## ***Interactive comment on “Synergy between in situ and altimetry data to observe and study the Northern Current variations (NW Mediterranean Sea)” by Alice Carret et al.***

**Alice Carret et al.**

Reply to reviewer #1

**Fig. 1.** Differences of the maximum amplitudes of the NC between the ADCP and SARAL (in red) and between the ADCP and J2 (in black) in function of the time difference

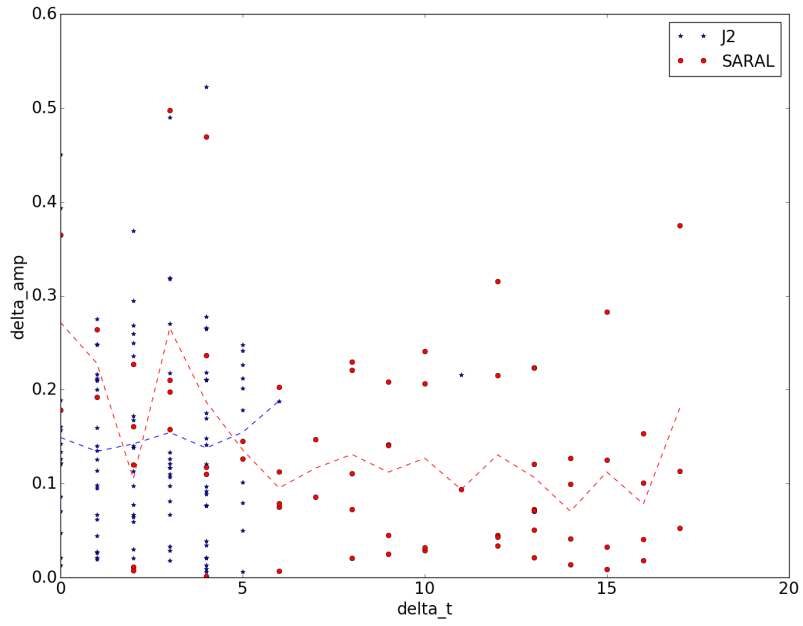
P20, L2-4 "but a quantification of the high frequency component of the coastal ocean dynamics that altimetry is able to capture would require data that are colocalized in both space and time." Completely agree. But with the dataset that you already have, you do have the possibility to quantify this quite precisely: how much is the bias that is introduced in the comparison because of non-colocalized data? Just compare, more precisely than what you have done so far, the "very close" space & time datasets with the "not very close".

by non-colocalized data in more details and have computed the diagnostics shown below. Using all the data available, we represent in Figure 1 and in Figure 2 the differences between the maximum NC amplitudes derived from in situ datasets (gliders and ADCP) and from altimetry (J2 and SARAL) as a function of the number of days which separates two measurements. In Figure 3 and 4 we represent the differences obtained as a function of the distance of the NC core to the coast. As you can see, unfortunately, these results don't allow to draw any conclusion because there are no clear rule that appears. The explanation is not really obvious. Is it because of the high level of short scale variability in this area? Difficult to say. A high resolution numerical model would probably help to understand but it is beyond the scope of this study.
